IMPORTANT SAFETY RECALL

NHTSA Number: 26V-246 (School Bus)

SUBJECT: R26AB: All Weather Wiper Blade Loose Nut

R26AB: All Weather Wiper Blade Loose Nut

Diagram A

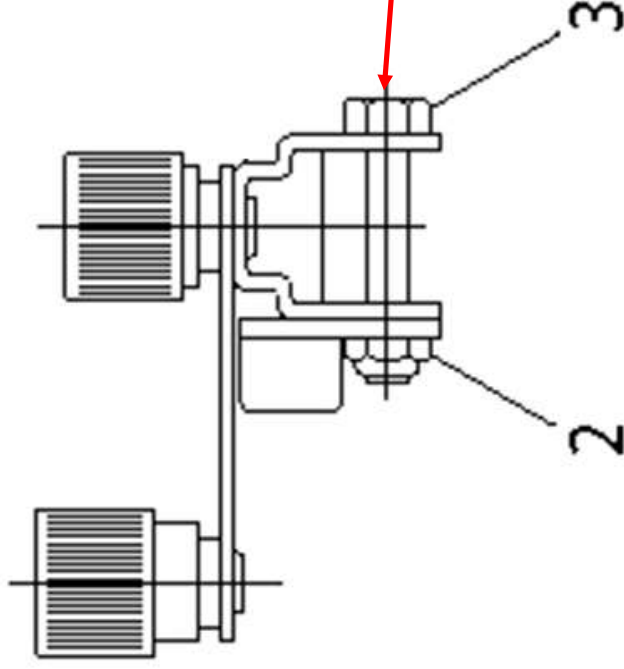
Replacement:

1. Remove and install new saddle nut (2) and bolt (3) as required and set torque to 8-10 ft-lbs. (11-13 Nm)
